OUTLINE - NORTHGATE PEDESTRIAN AND BICYCLE BRIDGE

DESIGN COMMISSION MAY 18, 2017

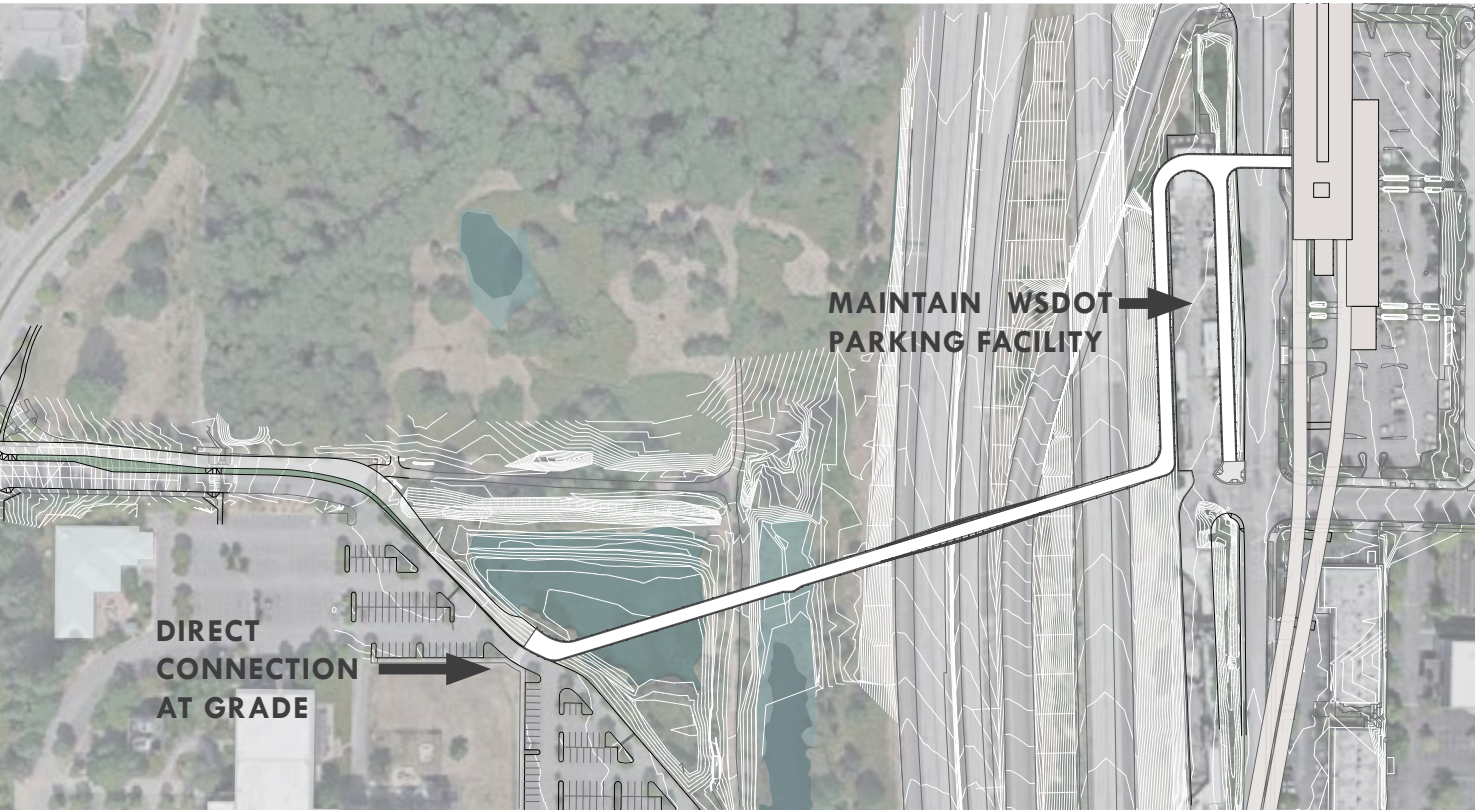
The SDC is very concerned with the proposed 8.3% slope on the west and east approach. Commissioners agreed the proposed slope, while at the legal maximum, would limit accessibility and highly recommended the design team [provide strategies for reducing the slope percentage](#).

Apply the principles of “universal accessibility” when designing bridge elements, especially when designing for the slope of the bridge. The lack of precedent is a concern for the proposed length and degree of slope.

‘Overall, this is an impressive effort to redesign a bridge to meet a much smaller budget. But, I have not seen a precedent where using 8.3% slopes allows a bridge to function well. I would have chosen to [make a condition to design the bridge at a slope of 5%, at least on the west approach](#). I think all users will benefit from the continued study of reducing the slope.’ Ben de Rubertis

Given the concerns of the Design Commission, the design team has [modified the design to slopes that not exceed 5%](#) between the west connection and the Sound Transit Station.

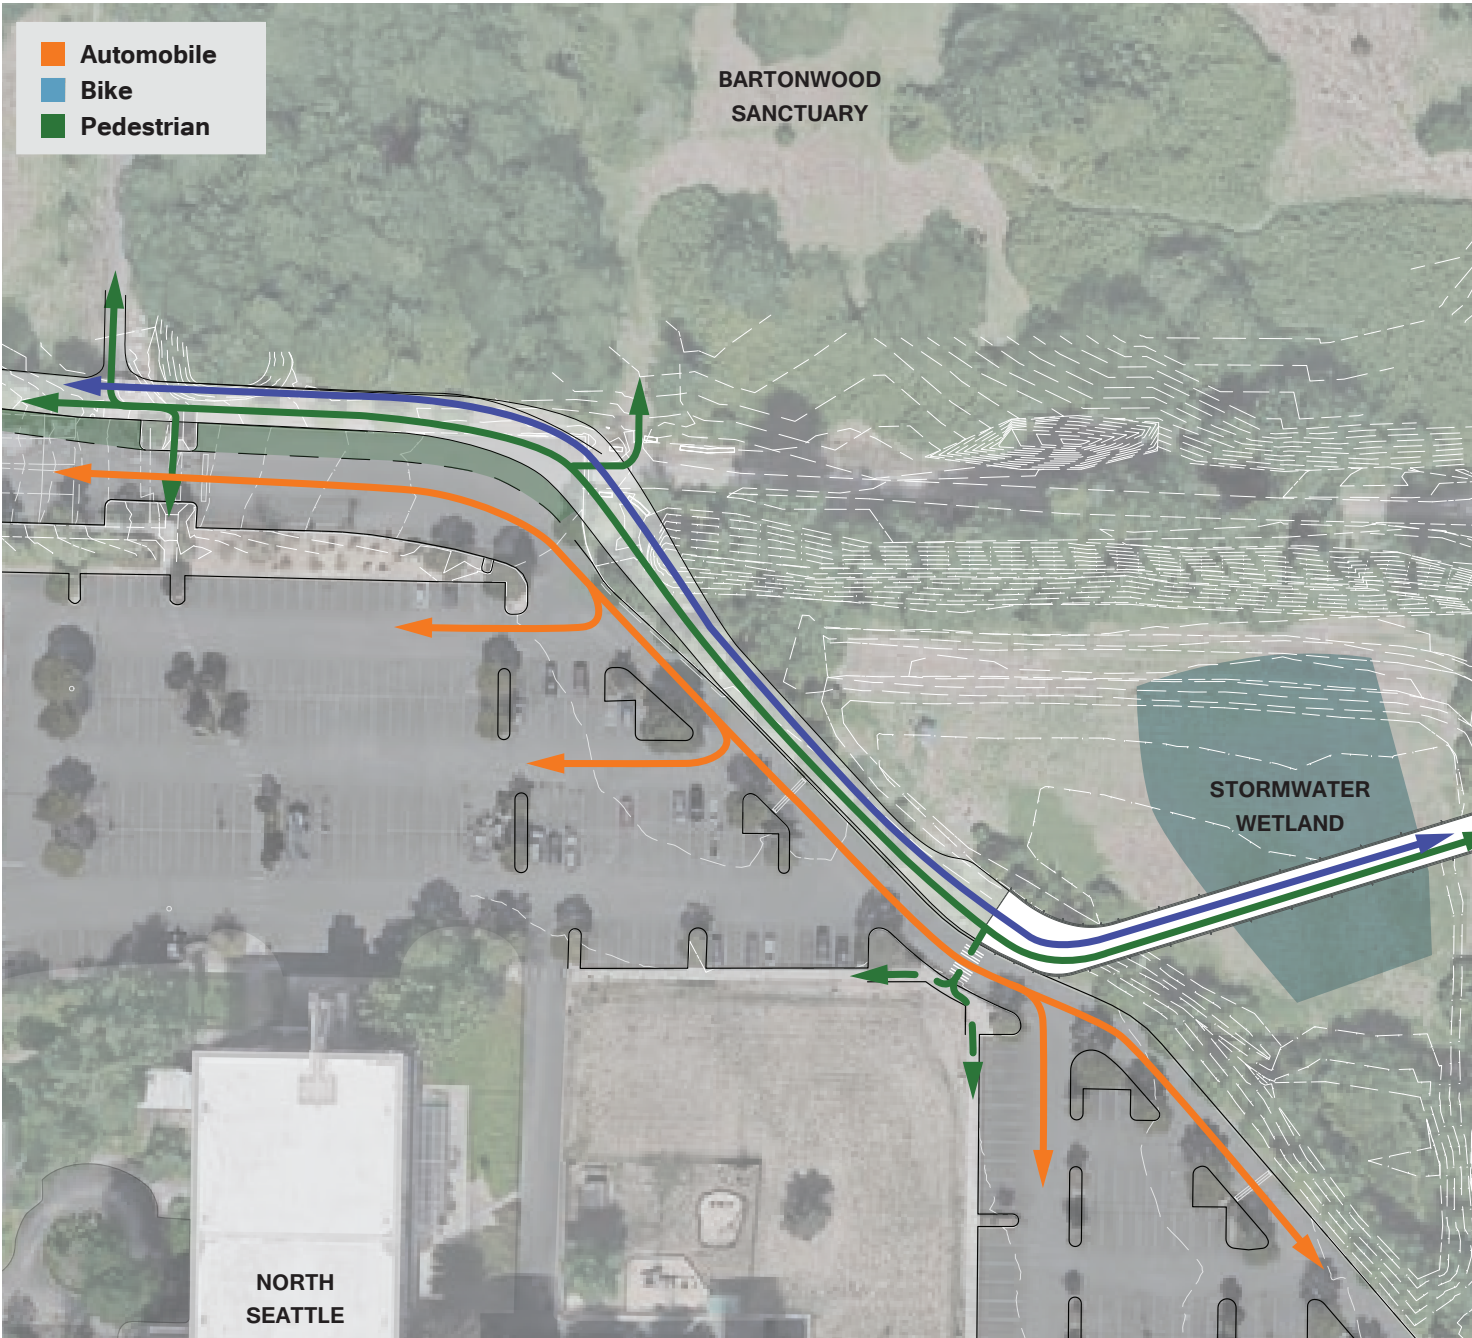
The commission is also concerned with potential conflicts between pedestrians and bicyclists at mixing zones at either bridge approach. Commissioners highly recommended the design team return with strategies for reducing conflicts through the use of materials and signage. The commission requested the dimension of the 1st Ave and 100th St intersection, turning radii, as well as vehicle volumes during peak hours. The commission recommended the project team provide strategies for reducing bicyclists' speed as they move through the project.

[Address pedestrian and bicycle safety at the mixing zones](#), specifically at the east landing near 1st Ave NE and NE 100 St.

The commission mentioned the design team should distinguish the view point from the pathway through the use of different paving materials.

- The design team has [enlarged landing areas](#) to allow for safe circulation. Visual and tactile cues have been added to increase awareness of mixing and slow circulation areas.
- Primary and secondary [wayfinding strategies have been developed](#) for the project.

REVISED ALIGNMENT - CIRCULATION AT EAST LANDING

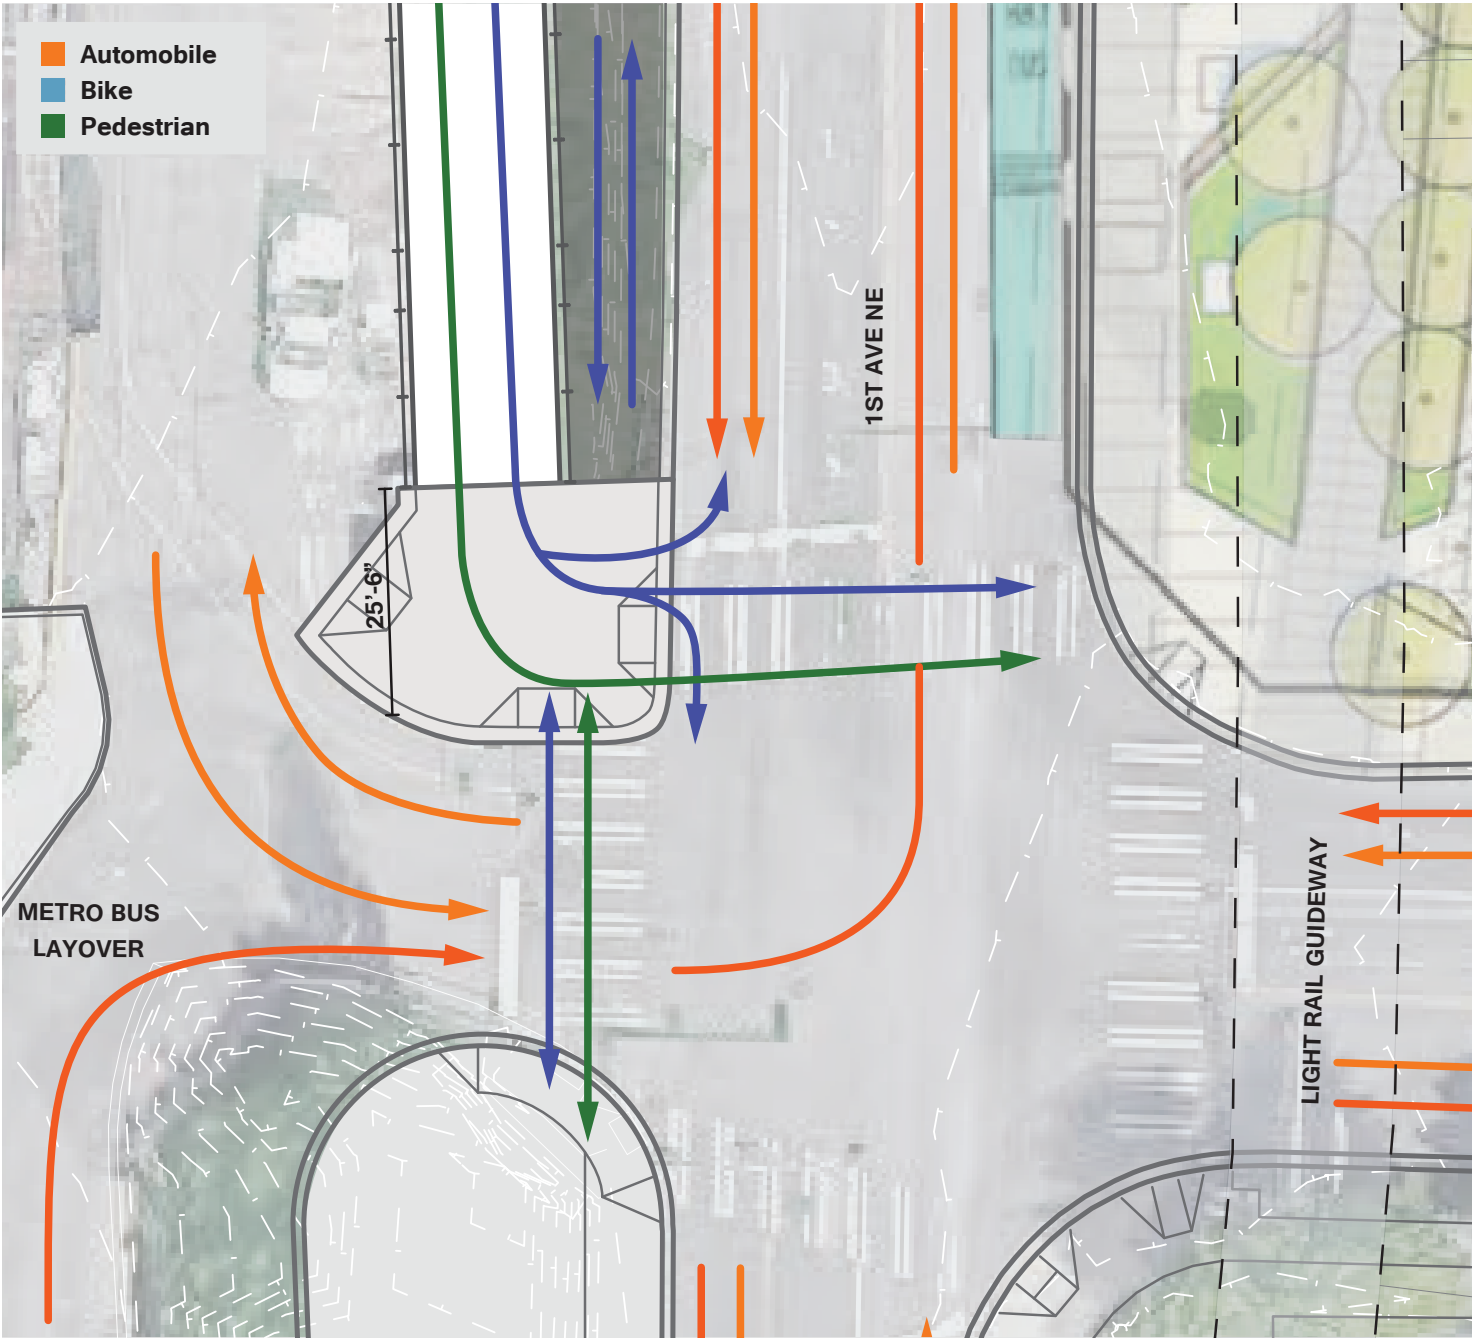
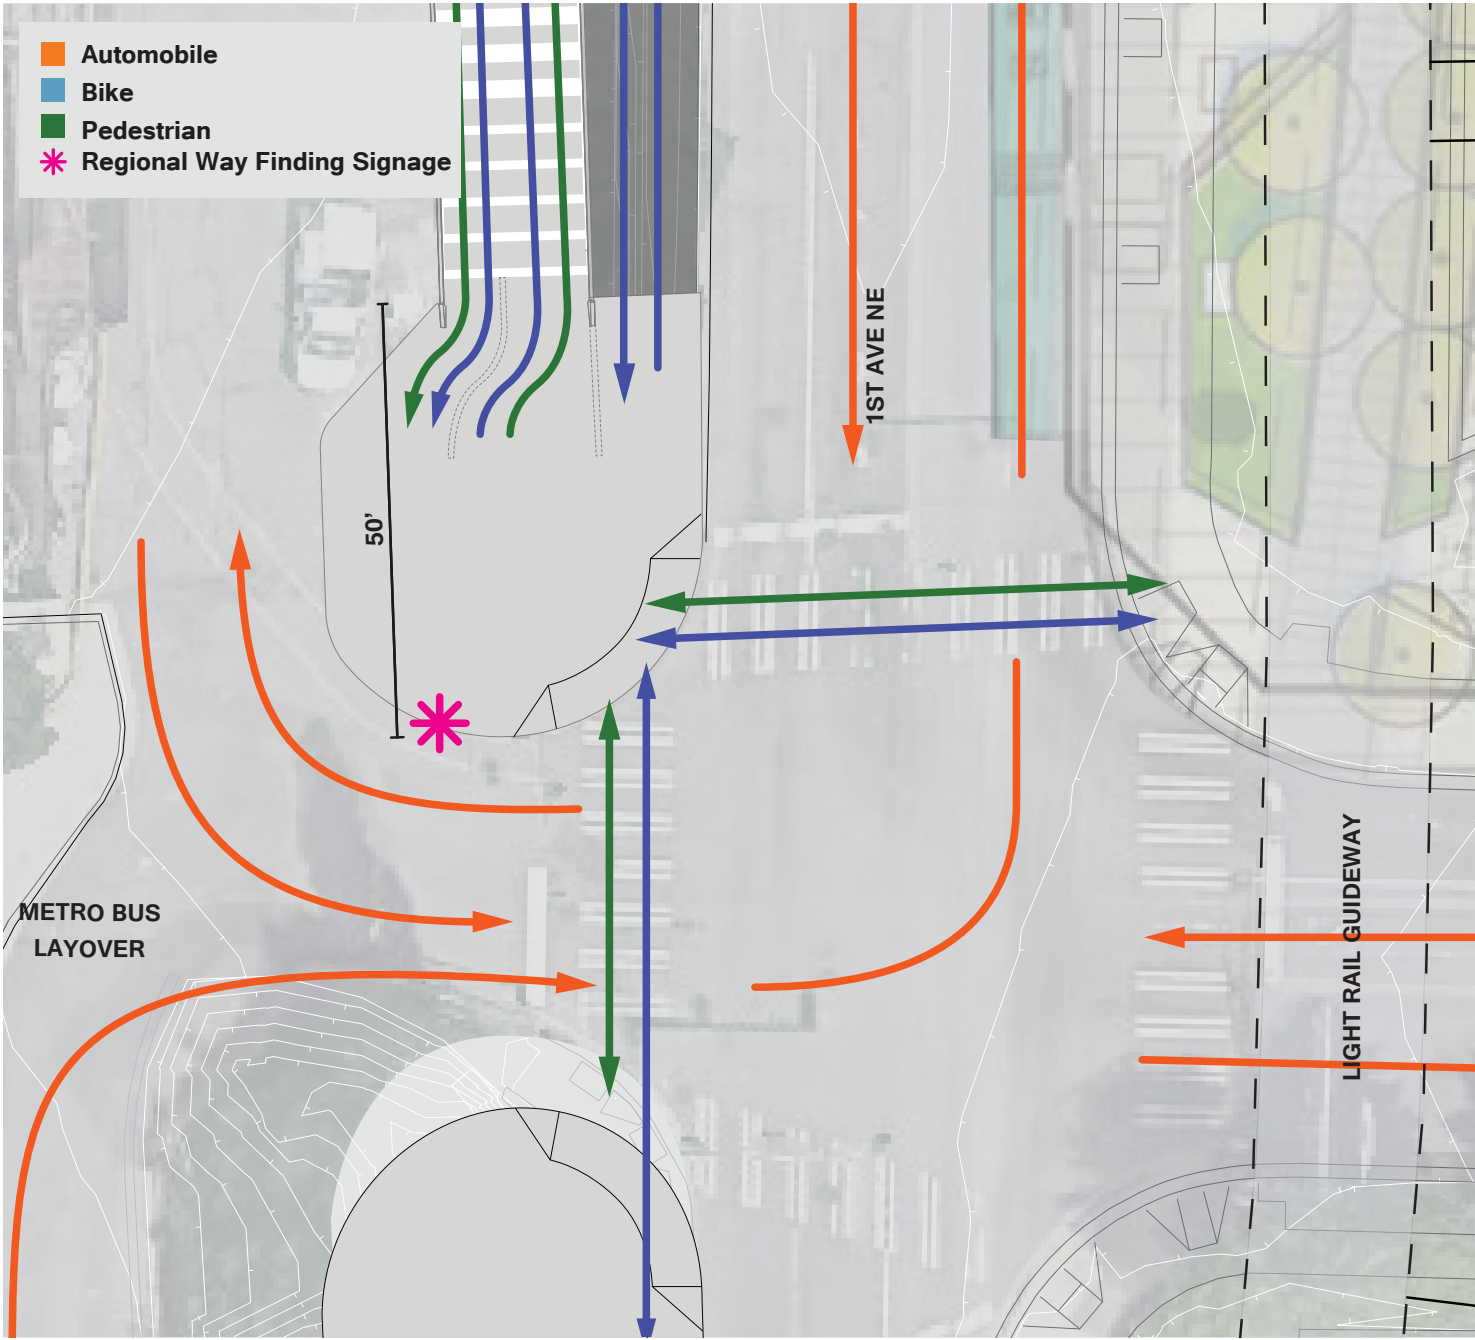
- Alignment and slopes created a constrained plaza area.

- Alignment optimized to double circulation area.
- Secondary cues added to enhance safe circulation paths.

MSE WALL AT THE EAST END

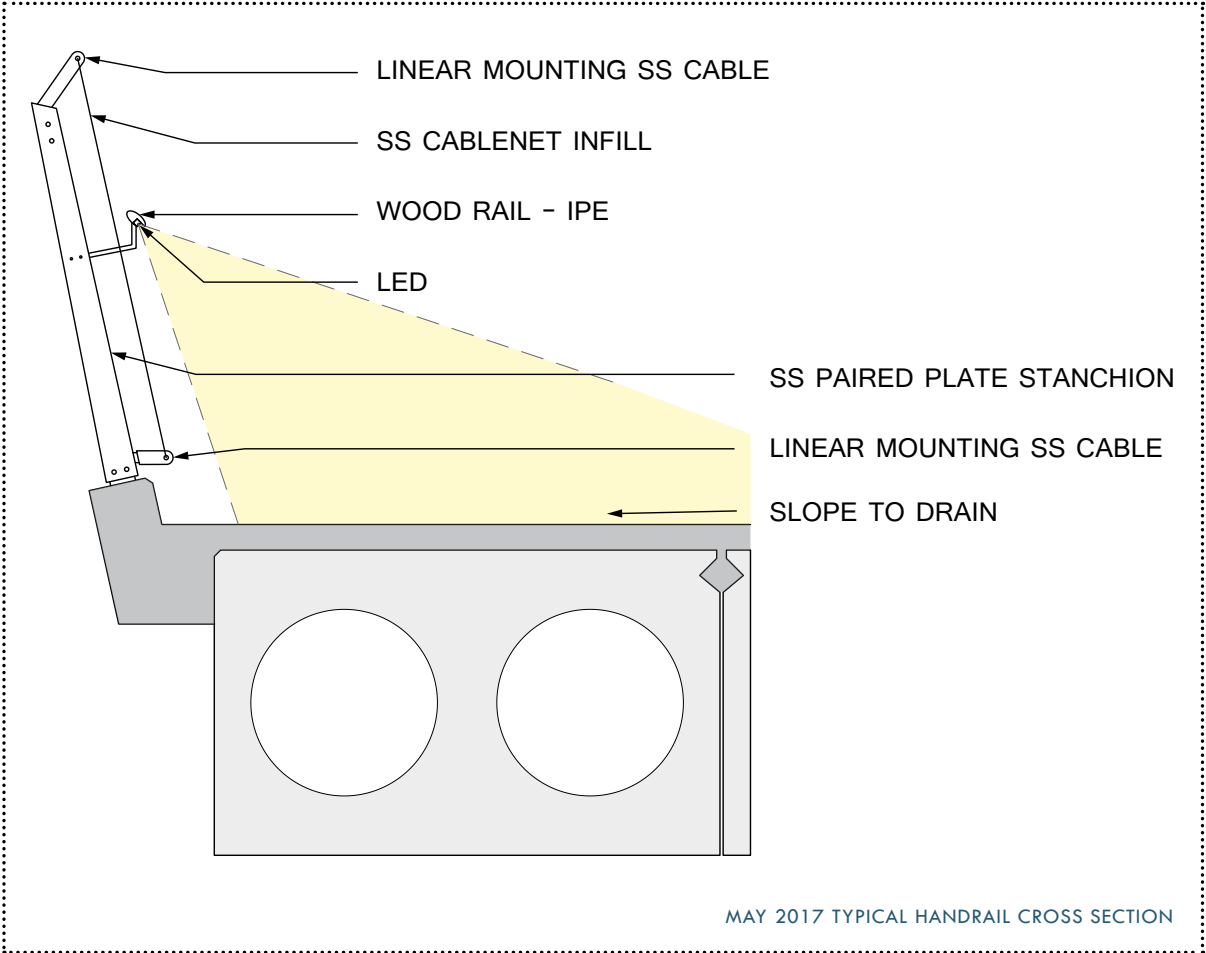
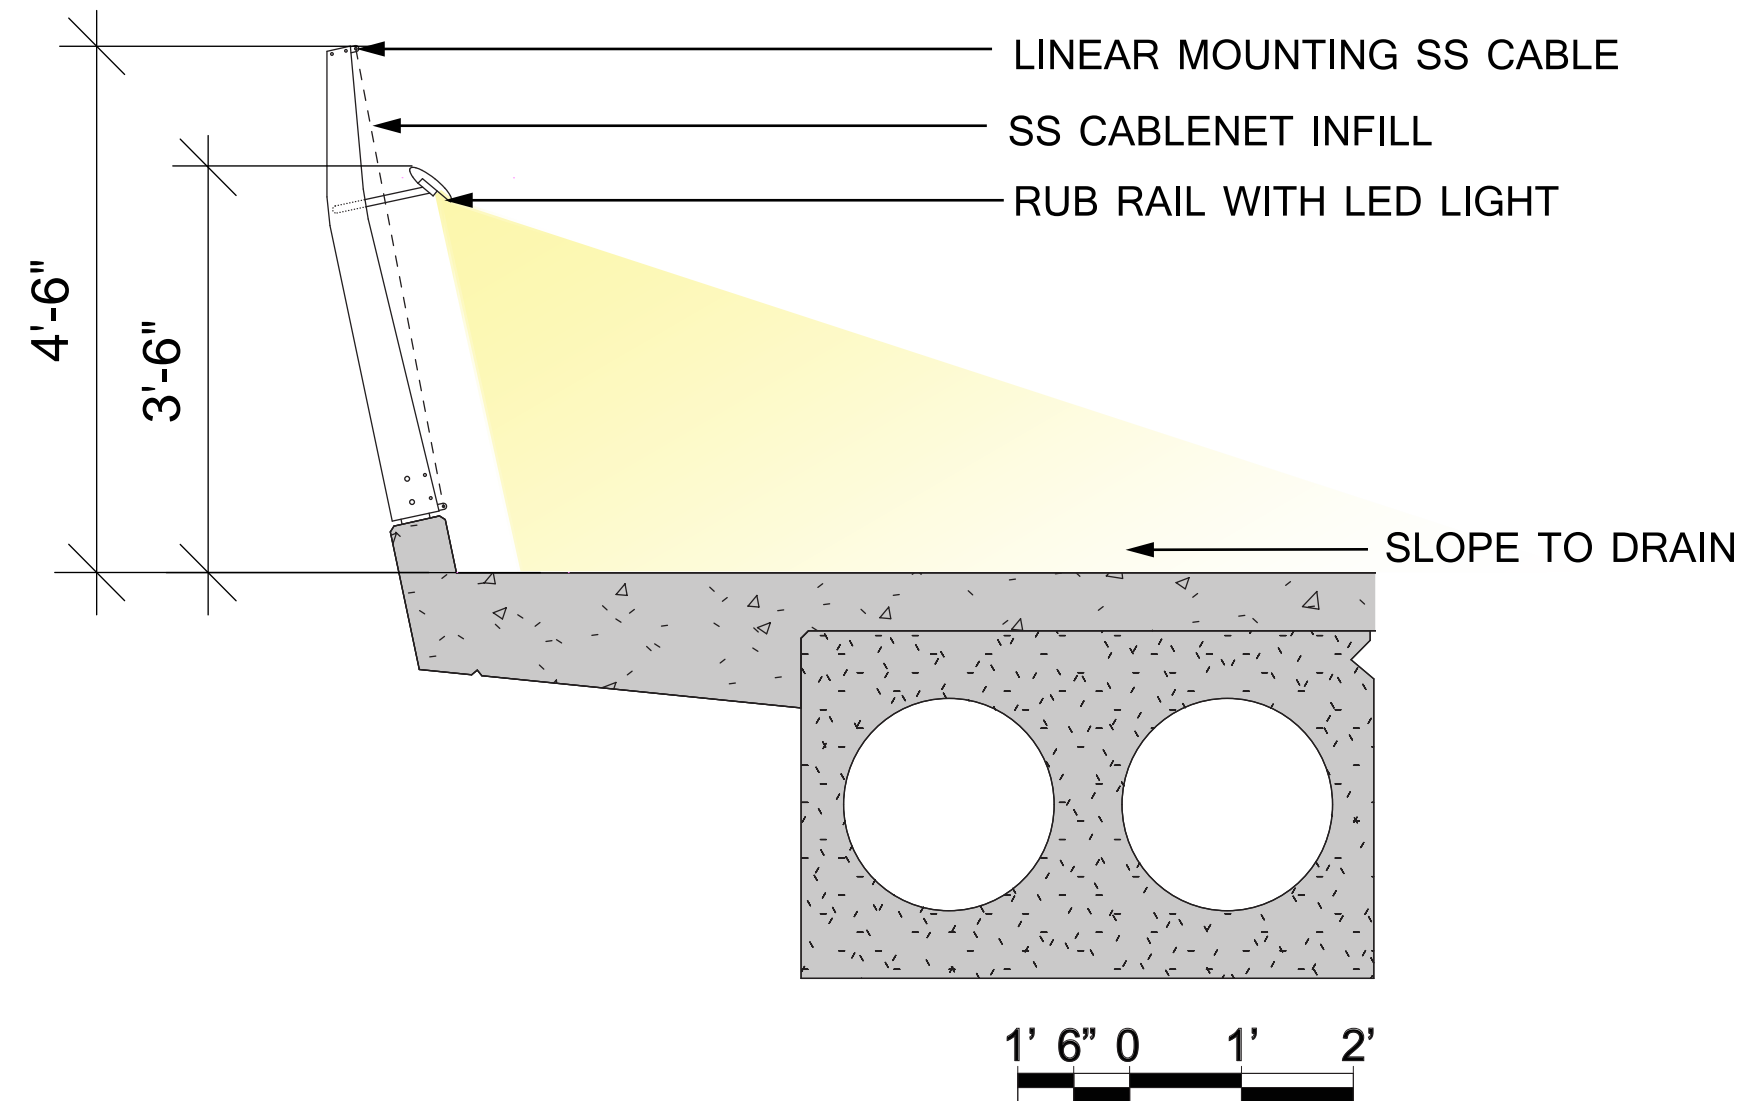
The commission questioned the length and façade treatment proposal for the wall on the west side of the bridge. Commissioners are concerned with the potential long term maintenance issues associated with using plants on the wall façade. The Commission highly recommended the project team **reduce the length of the proposed wall on the west side of the bridge** in order to reduce potential long term maintenance issues and to increase visibility. Explore minimizing the length of the wall on the west side in order to improve stormwater flow, enhance views, and to minimize the bulkiness of the bridge design.

- The alignment and slope reconfiguration has allowed for the reduction in length and height of this wall structure.
- Plantings will be utilized along the south face of the wall to soften the wall and reduce its scale, while still allowing for ease of maintenance and inspection of the structure.
- Form liners will add a secondary patternization to the structure.
